**Andrew Johnson Complex**

**Assessment October 23, 2018**

## ADA Checklist for Existing Facilities

**Building:** Andrew Johnson Complex – first floor

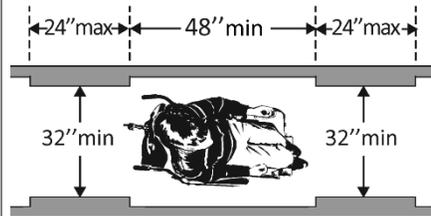
**1.14** Is the route at least 36 inches wide?  
[403.5.1]

Yes

Measurement:  
6'-4"

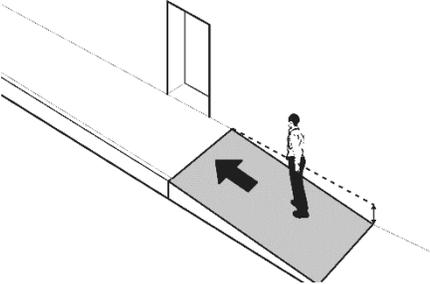
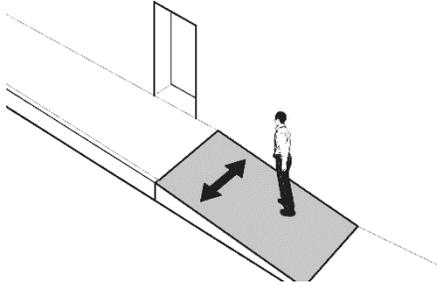
| <p><b>1.17</b> Is the running slope no steeper than 1:20, i.e. for every inch of height change there are at least 20 inches of route run?<br/>[403.3]</p> <p>Note: If the running slope is steeper than 1:20, treat as a ramp and add features such as edge protection and handrails.</p> | <p>Yes</p> <p>Measurement:</p> |  |  |  |

| <p><b>1.18</b> Is the cross slope no steeper than 1:48?<br/>[403.3]</p> | <p>No<br/>Measurement:</p> |  |  | <ul style="list-style-type: none"> <li>• Regrade to 1:48 max.</li> </ul> <p>Budget Year: 2024<br/>Cost: \$3,500</p> |

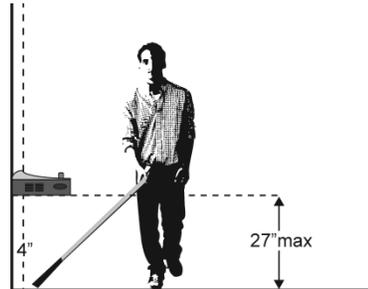
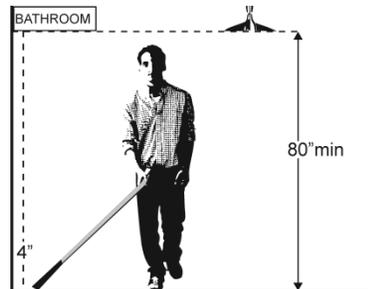
**2.8** Do all objects on circulation paths through public areas, e.g. fire extinguishers, drinking fountains, signs, etc., protrude no more than 4 inches into the path?

No  
Measurement:

No  
Measurement:  
42 inches

- Remove objects
- Add tactile warning such as permanent planter or partial walls

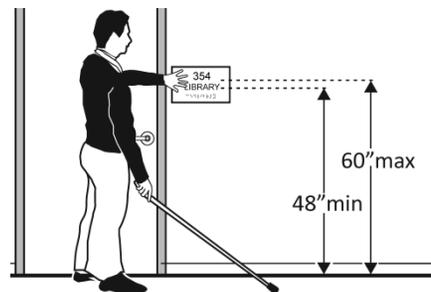
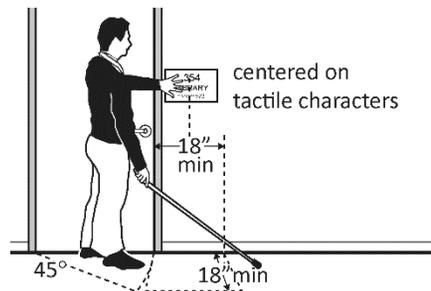
If there are signs designating permanent rooms and spaces not likely to change over time, e.g. room numbers and letters, room names, and exit signs: [216.2]

No

No

No

- Install tactile sign

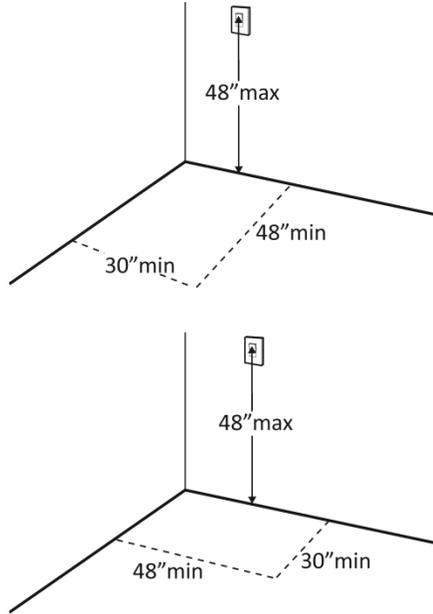
**2.50** Is there a clear floor space at least 30 inches wide by at least 48 inches long for a forward or parallel approach?  
[305.3]

No  
Measurement:

- Remove obstructions

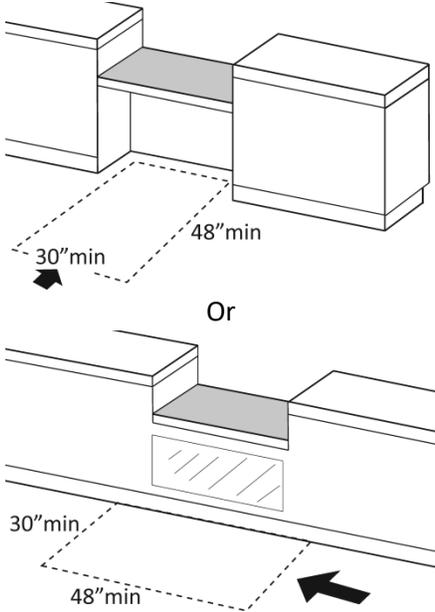
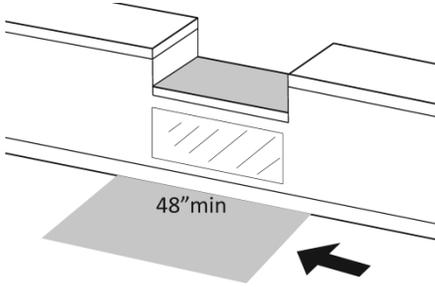
**2.76** Is there a portion of at least one of each type of counter that is:

No  
Measurement:  
45 inches

- Lower section of counter
